MEMORANDUM

Subject: Addendum to MovingAhead Alternatives Analysis Technical Reports

This document is an addendum to the MovingAhead Project's Alternatives Analysis (AA) Draft Final Technical Reports, dated May 2017. This addendum serves to provide new options for mitigating potential adverse effects as related to the information gathered by the AA Technical Reports.

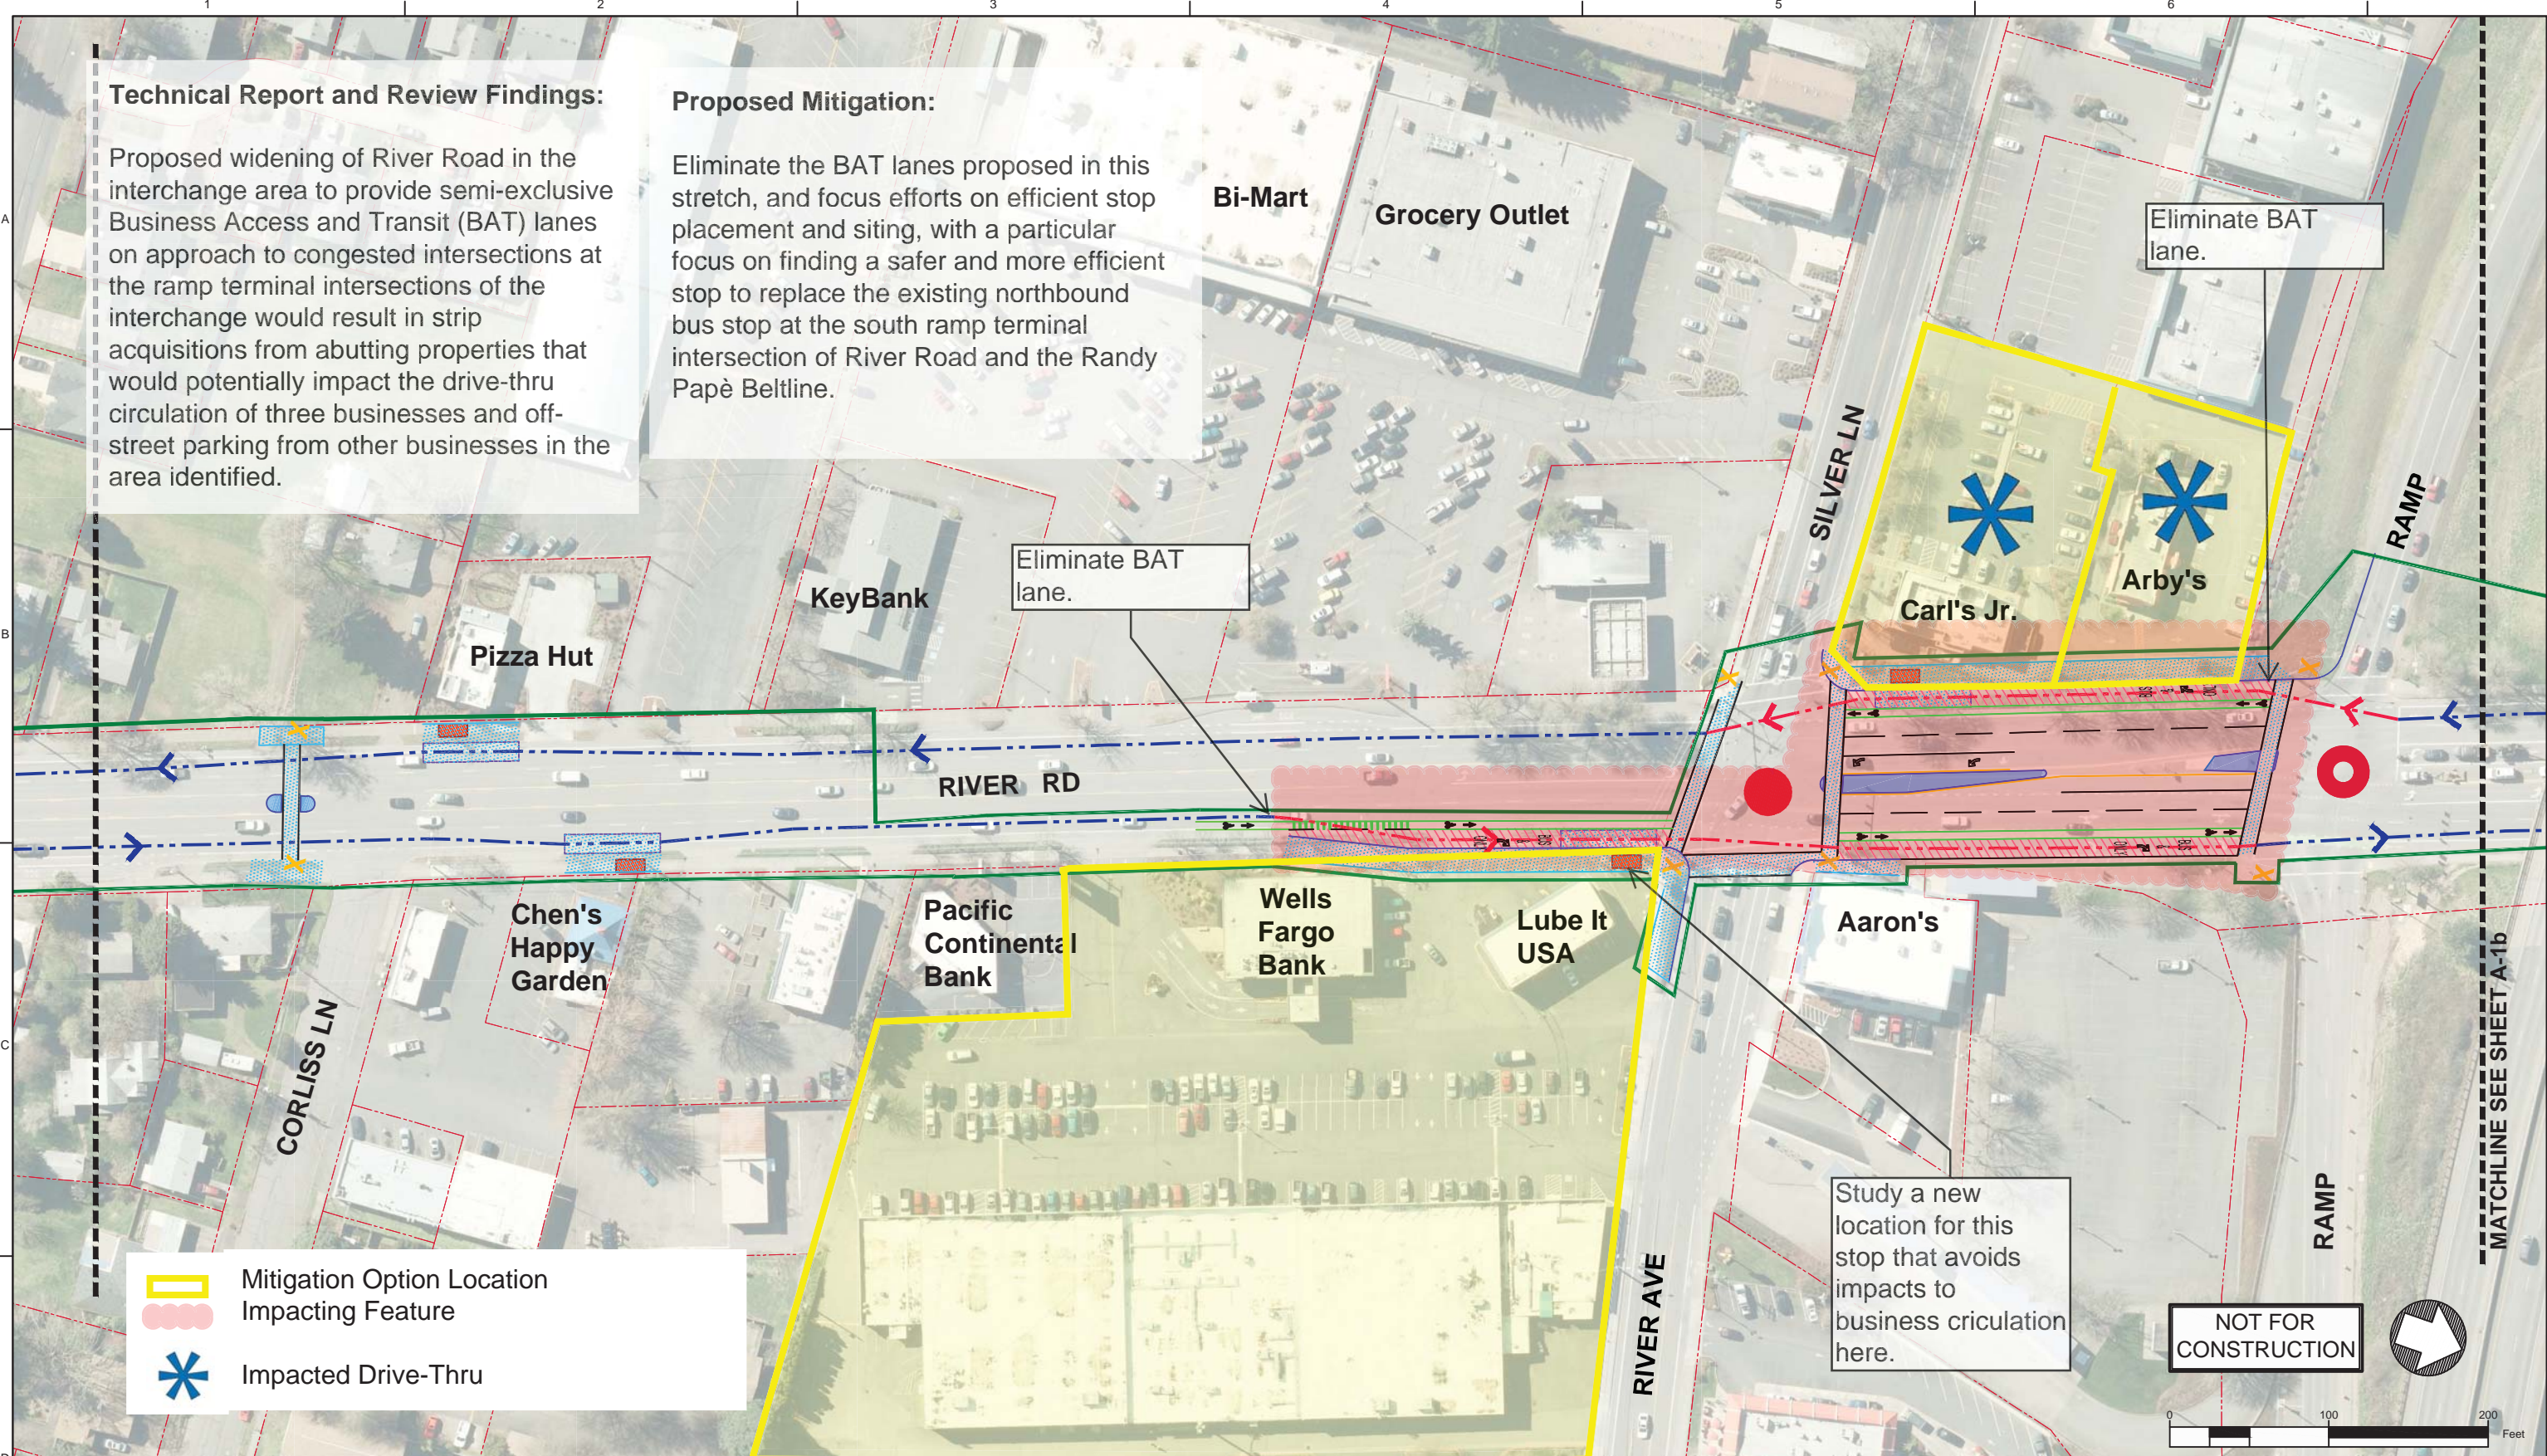
Proposed widening of River Road in the interchange area to provide semi-exclusive Business Access and Transit (BAT) lanes on approach to congested intersections at the ramp terminal intersections of the interchange would result in strip acquisitions from abutting properties that would potentially impact the drive-thru circulation of three businesses and off-street parking from other businesses in the area identified.

Eliminate the BAT lanes proposed in this stretch, and focus efforts on efficient stop placement and siting, with a particular focus on finding a safer and more efficient stop to replace the existing northbound bus stop at the south ramp terminal intersection of River Road and the Randy Papè Beltline.

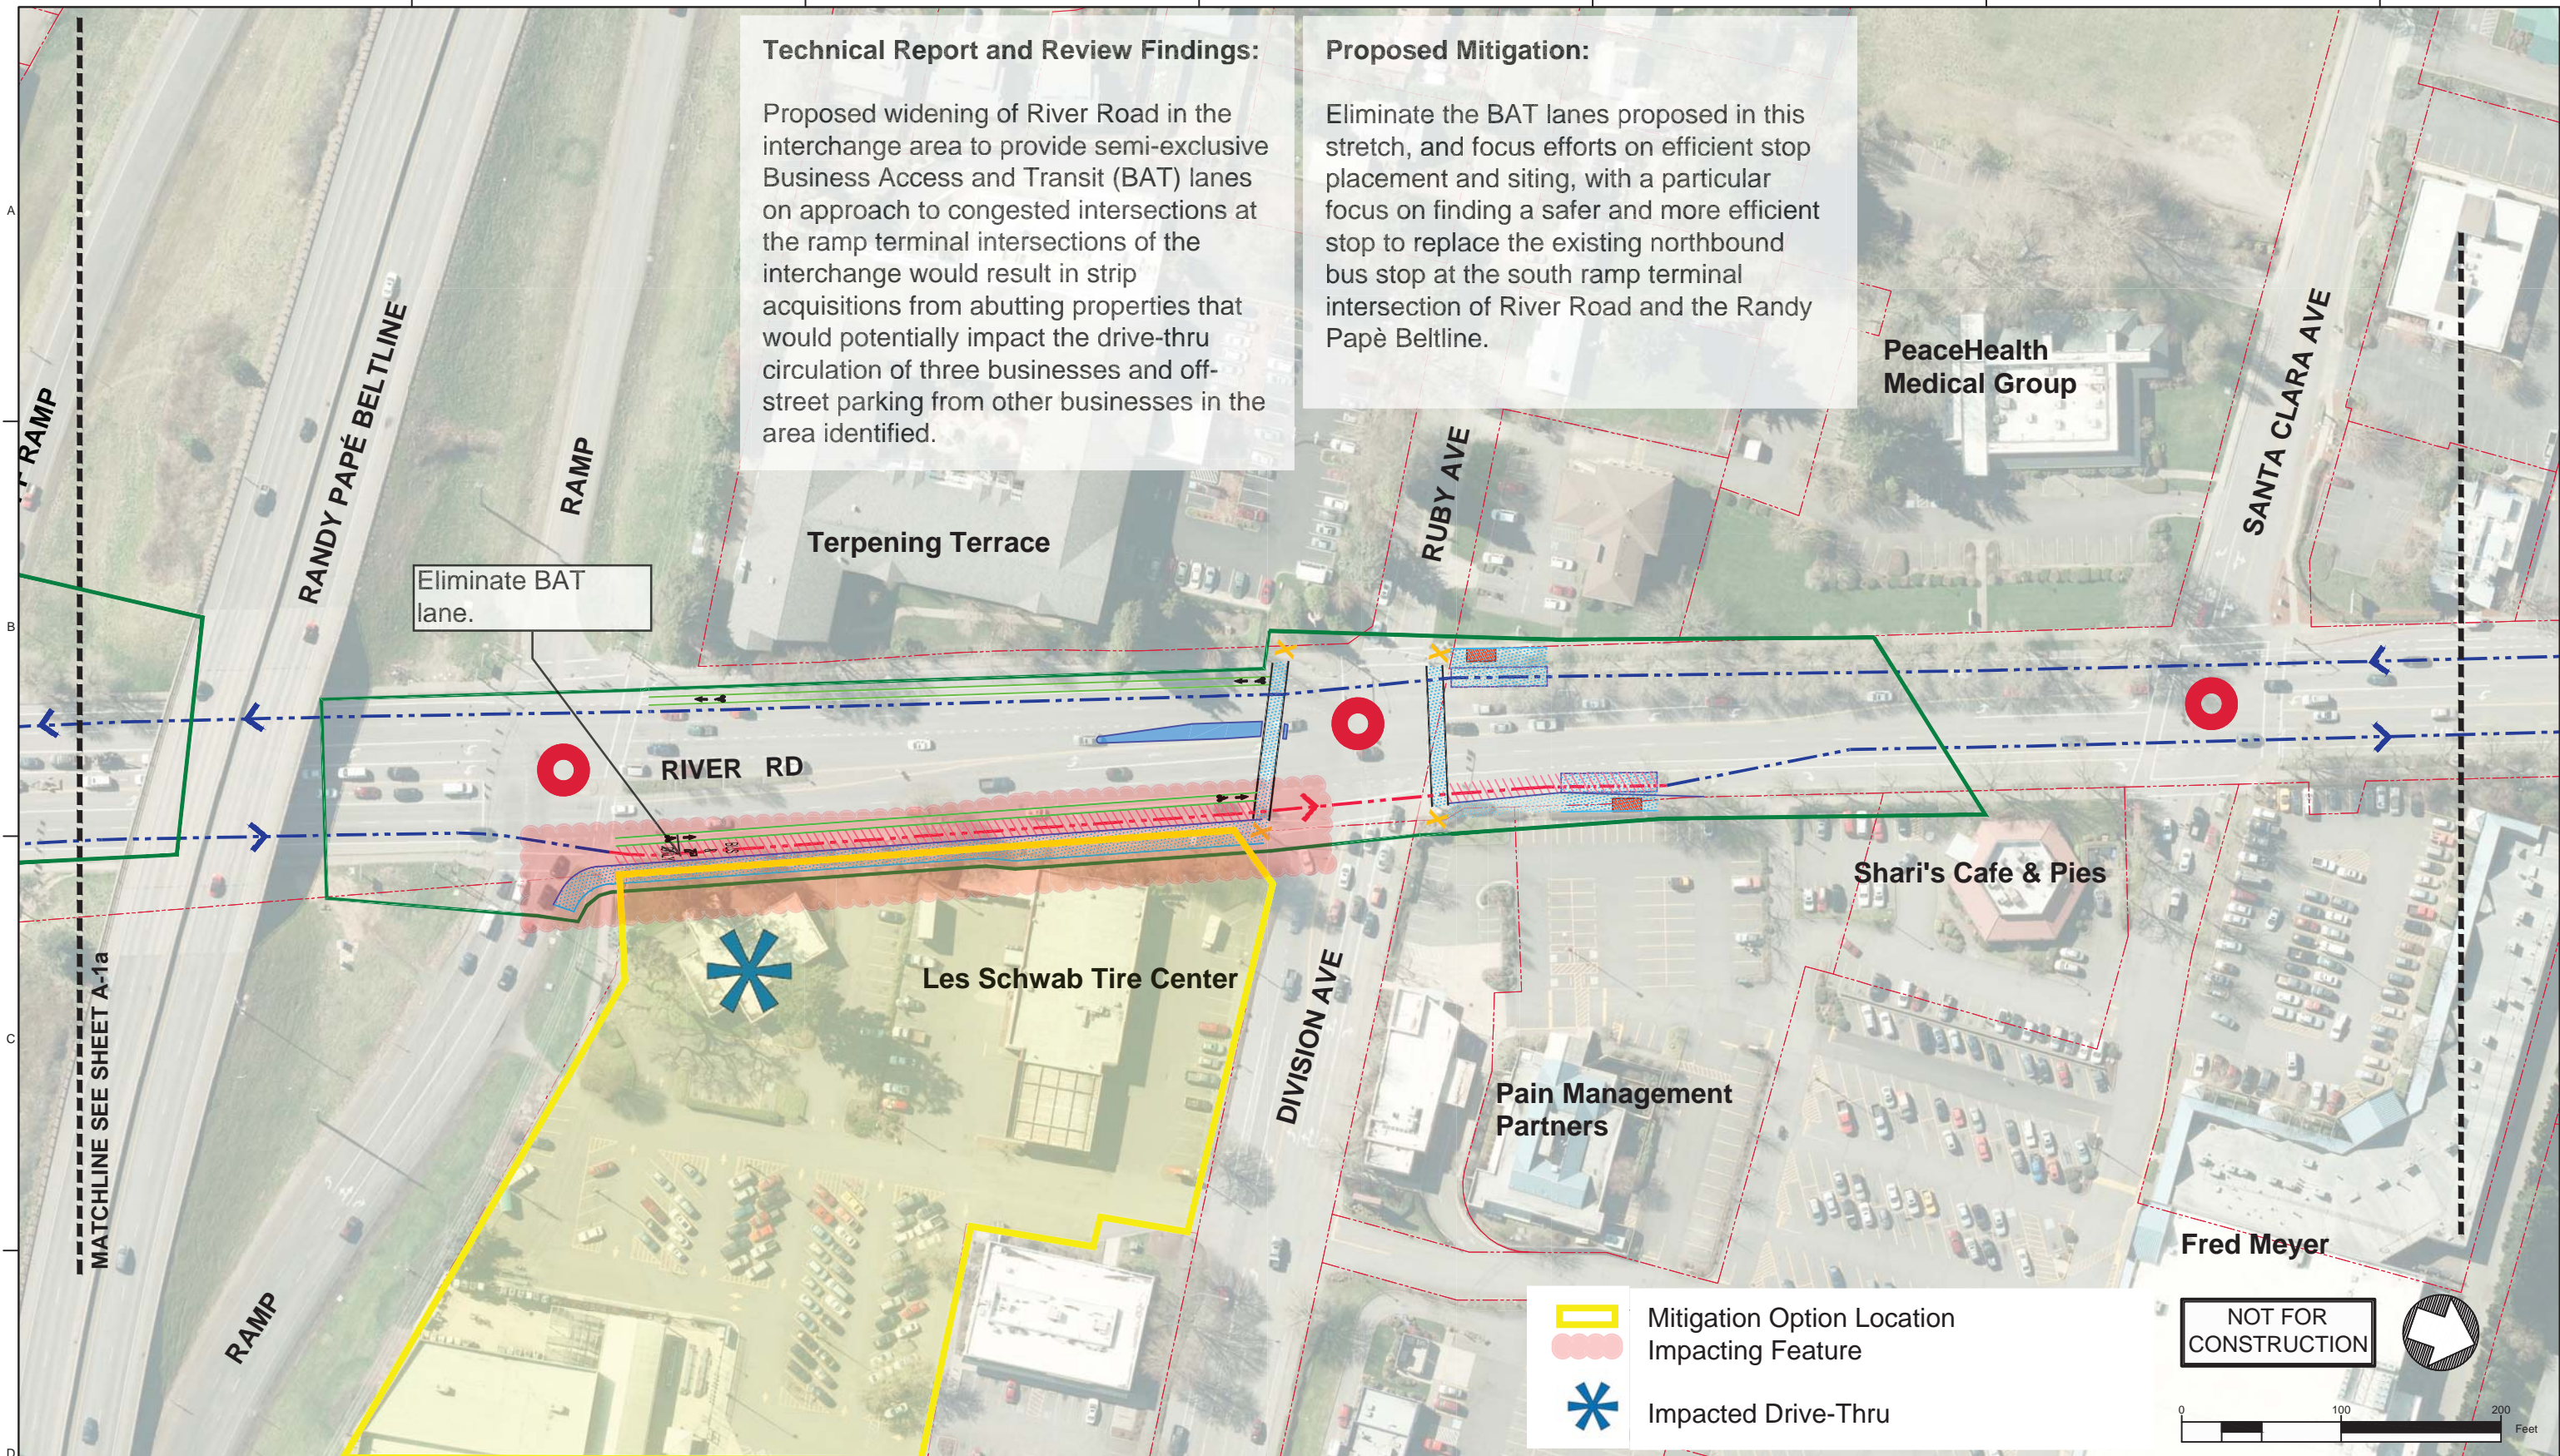
Proposed widening of River Road in the interchange area to provide semi-exclusive Business Access and Transit (BAT) lanes on approach to congested intersections at the ramp terminal intersections of the interchange would result in strip acquisitions from abutting properties that would potentially impact the drive-thru circulation of three businesses and off-street parking from other businesses in the area identified.

Eliminate the BAT lanes proposed in this stretch, and focus efforts on efficient stop placement and siting, with a particular focus on finding a safer and more efficient stop to replace the existing northbound bus stop at the south ramp terminal intersection of River Road and the Randy Papé Beltline.
